**ANGELO'S AGGREGATE MATERIALS  
ENTERPRISE RECYCLING AND DISPOSAL FACILITY  
CLASS III OPERATIONS PERMIT MINOR  
MODIFICATIONS—UPDATES**

Revised  
10/22/09  
11/23/09

Re: Angelo's Recycled Materials Class III Landfill and Recycling Facility  
Permit Application Modification #177982-016-SO/MM to Existing  
Operation Permit #177982-007-SO-T3 and #177982-017-SC/MM to Existing  
Construction Permit #177982-008-SC/T3  
Response to FDEP Request for Additional Information  
Jones Edmunds Project No. 95380-436-09

This letter has been prepared in response to the request for additional information (RAI) prepared by the Florida Department of Environmental Protection (Southwest District Office), dated September 4, 2009. Each of the Department's comments is presented below in *italics*, followed by the response in **bold type**.

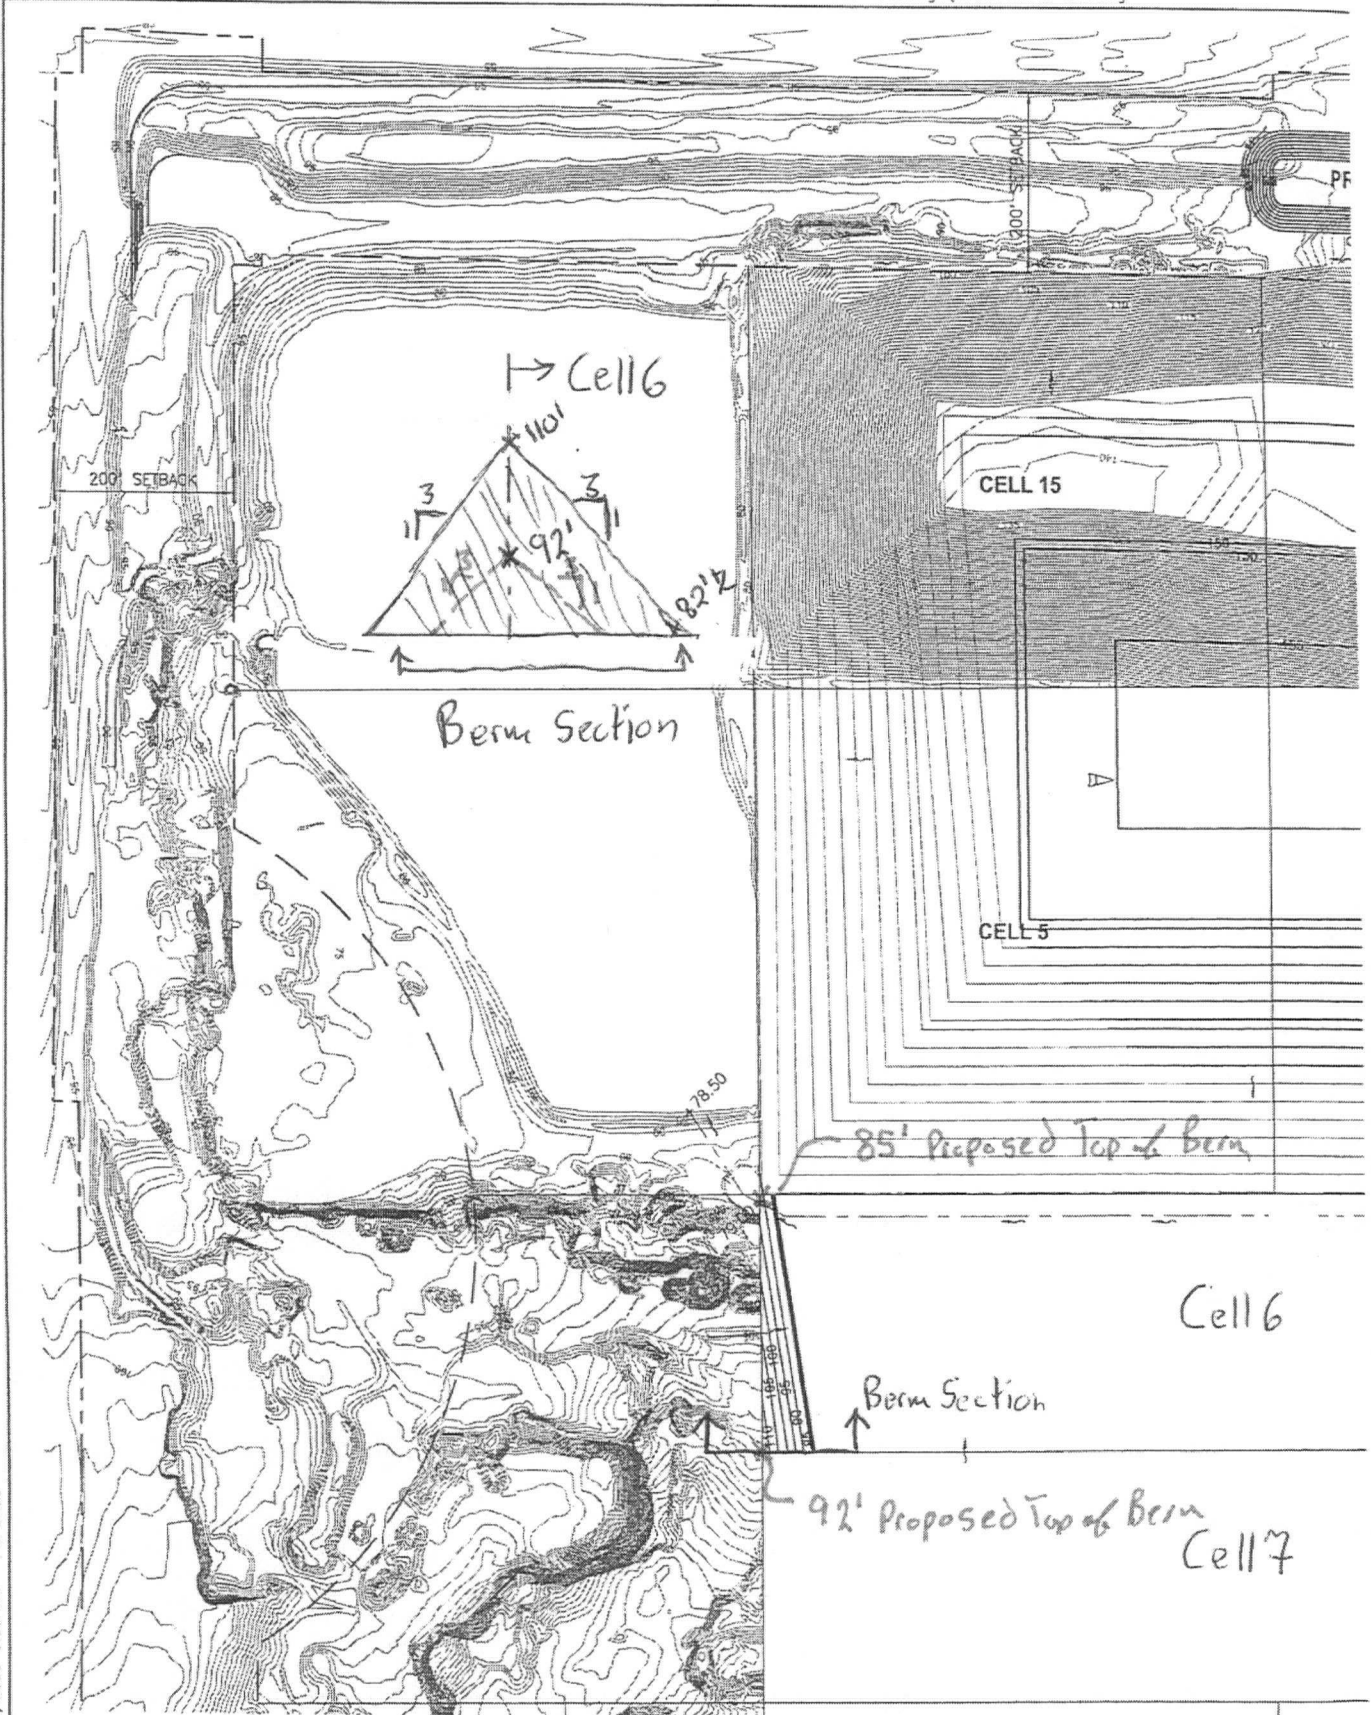
In looking at the berm on the north side of Cell 6, the Jones Edmunds drawings do not have the tie to grade of the berm outside of the cell. I propose to make it 3 (horizontal) to 1 (vertical) per the attached sketch (which is the cell 6 top of clay drawing). I also would like to request that the height of the berm be allowed to be constructed to the grades shown (in red), which would provide natural containment and a visual bufferer. As shown by Jones Edmunds, the proposed berm is close to 30' high without any tie to grade to the north. I talked to the Carol and Don at Jones Edmunds and they don't have an engineering reason for the berm being this high, which is why I would ask for the field deviation (which I think still provides a substantial berm). I confirm that the drawings will be revised for the pending permit renewal application to address these and any other "unclear" or "invalid" elements. Thank you for your consideration on this item.

With regard to the small berm along the north side of Cell 6, it was my desire to represent its absence as a minor field deviation. Since any liquid on the bottom of Cell 6 drains by gravity to the same location to the east, the absence of the small berm does not affect the design or function. However, if that is not acceptable, I can build the berm and provide you with an as-built.

The Department does not consider the absence of the berm as a minor field deviation, as discussed during the November 30, 2011 meeting and in the RAI for the Cell 6 certification. At the permittee's discretion, you may either install the permitted berm or revise the permit drawings (as part of the above described permit modification or permit renewal). Approval of Cell 6 certification is pending completion of one of these options.

Top of Clay Grading Plan

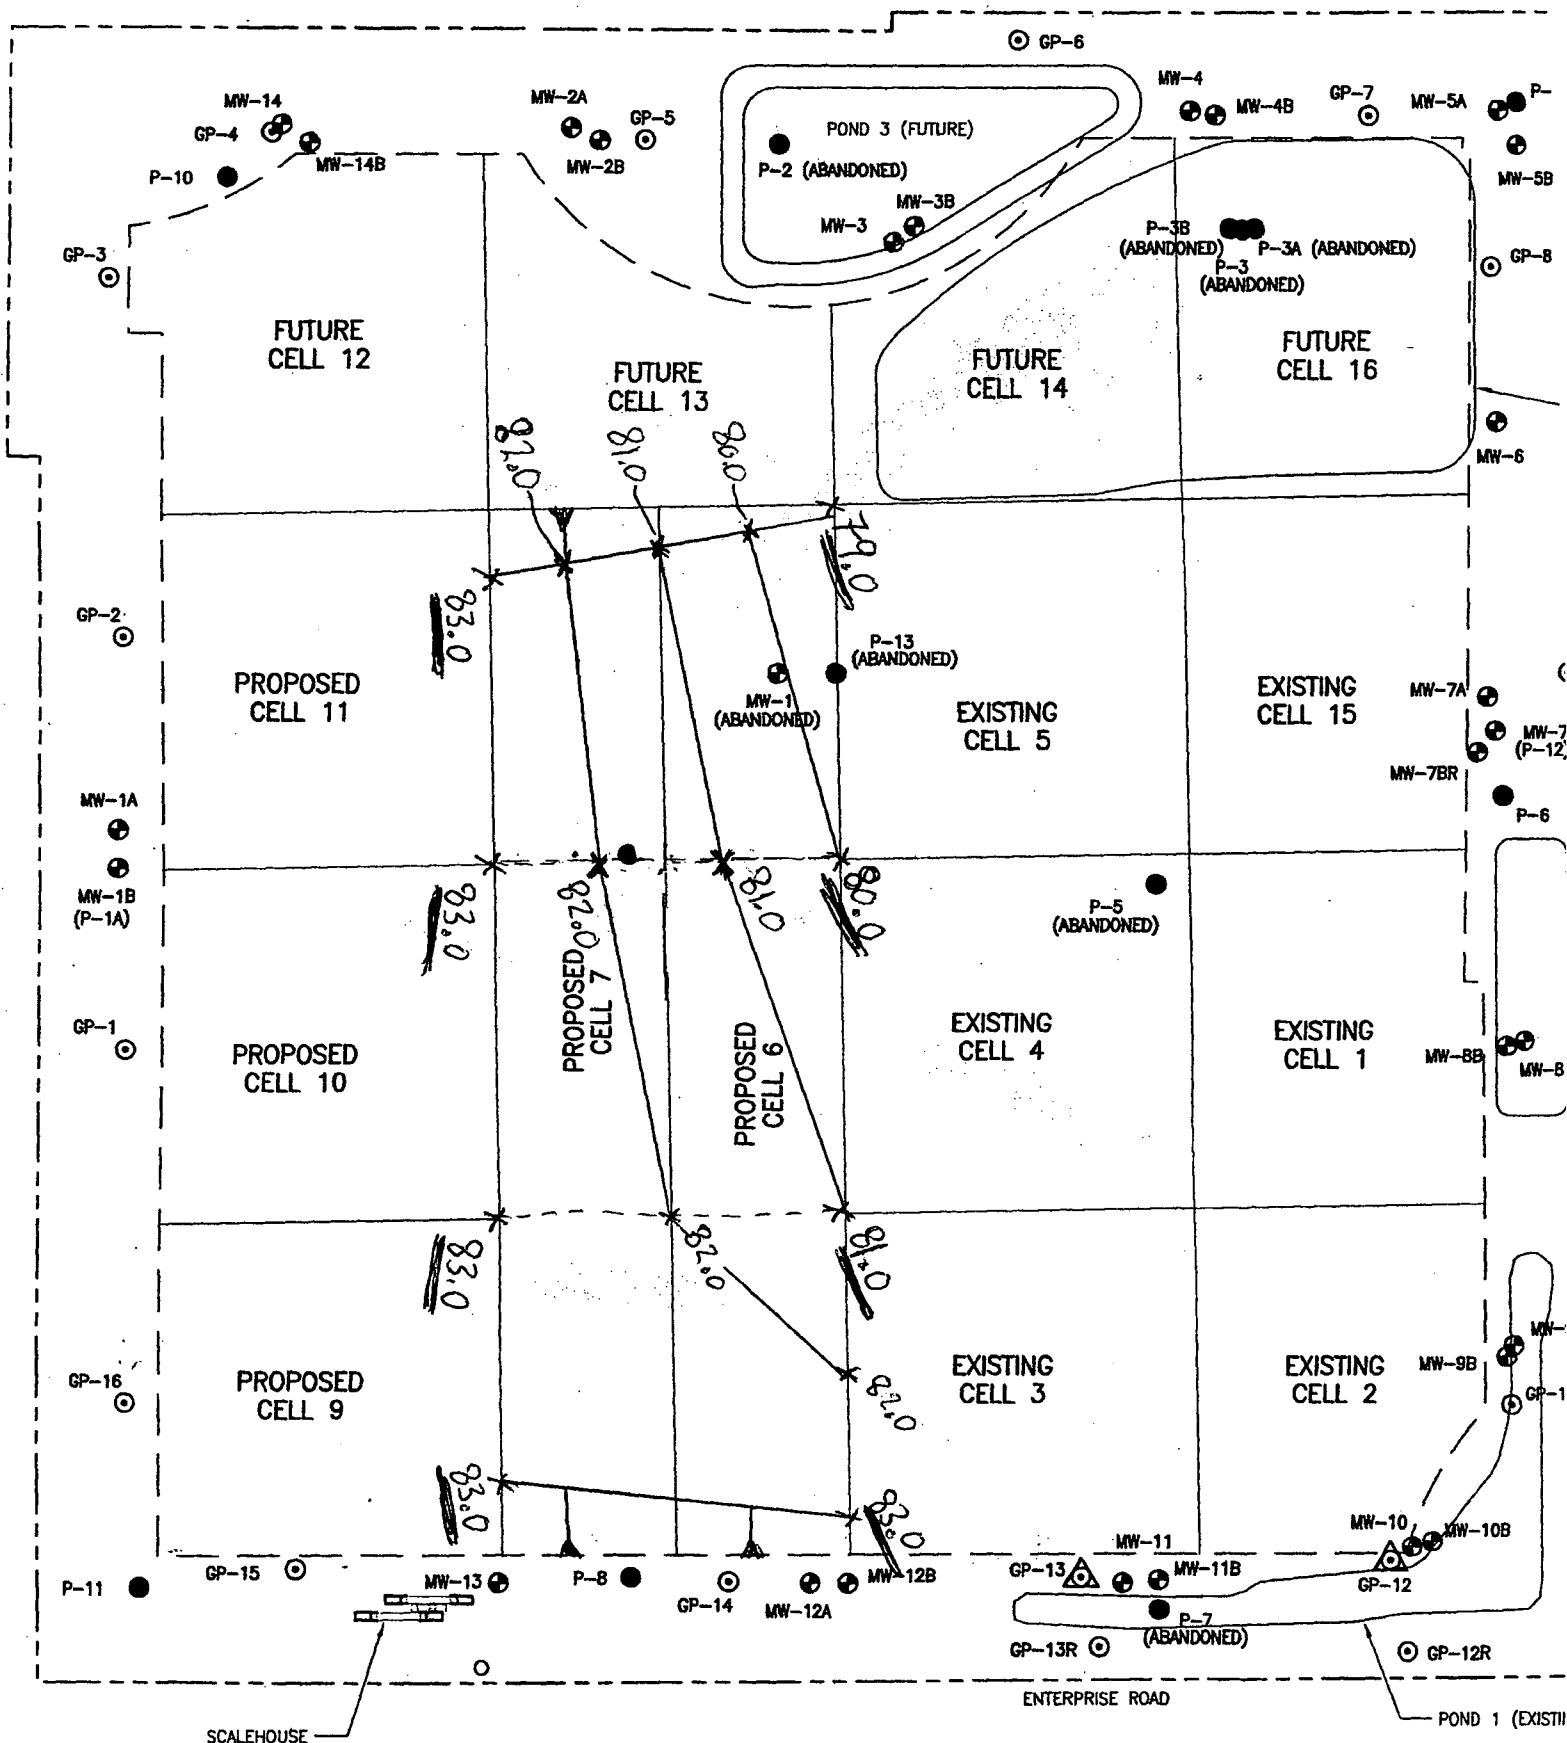
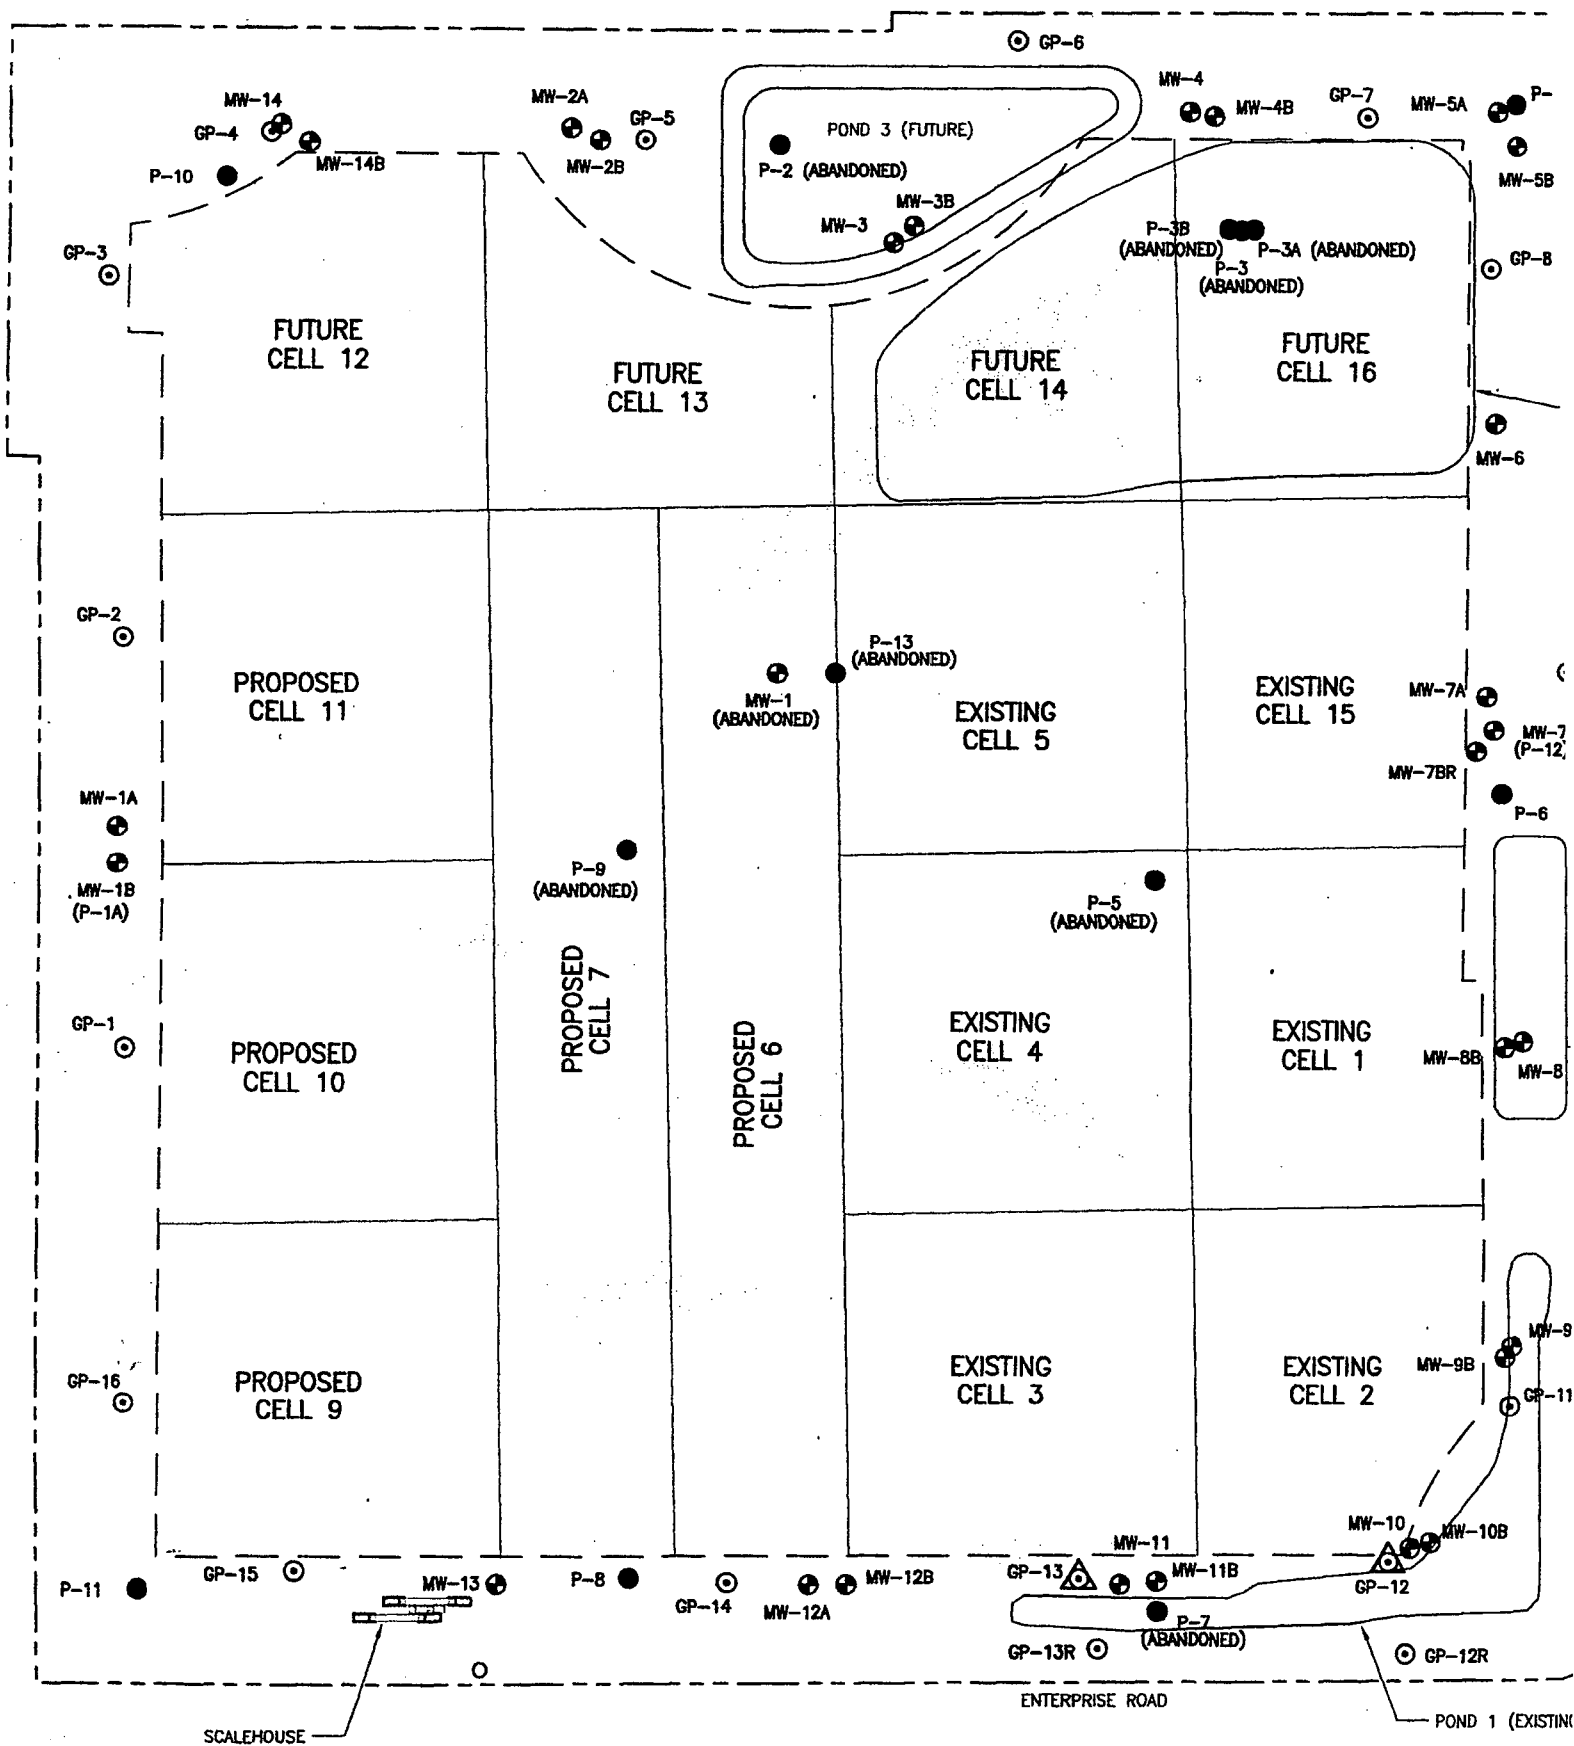
I was looking at the drawings for cells 6 and 7 (Enterprise Road Class III landfill) that were approved as part of the last modification (Jones Edmunds October 2009) and noticed that they did not have the top of clay grades, which were included in the November 2006 application. I've attached copies of the drawings (8 1/2" x 11"), all of which represent top of clay for the individual fill sequences.

As you recall, cells 6 and 7 were reconfigured as part of a modified fill sequence, which is probably why they did not include the top of clay elevations. I've transcribed the top of clay elevations from the 2006 drawings onto the 2009 drawing and have created what I think is the top of clay grading plan. The corresponding bottom of excavation would be 3' or greater in depth from the top of clay. On the the consolidated "top of clay grading plan", I've underlined the spot elevations from the other individual drawings and linearly interpolated the other elevations and drew topographic lines.

Please look at this "top of clay grading plan" and let me know if it is acceptable, or if you have any questions or ideas on what would be acceptable. We are still in the borrow pit phase for those cells (6 and 7), but the sub-grades are getting close and I don't want to have to rework those areas.
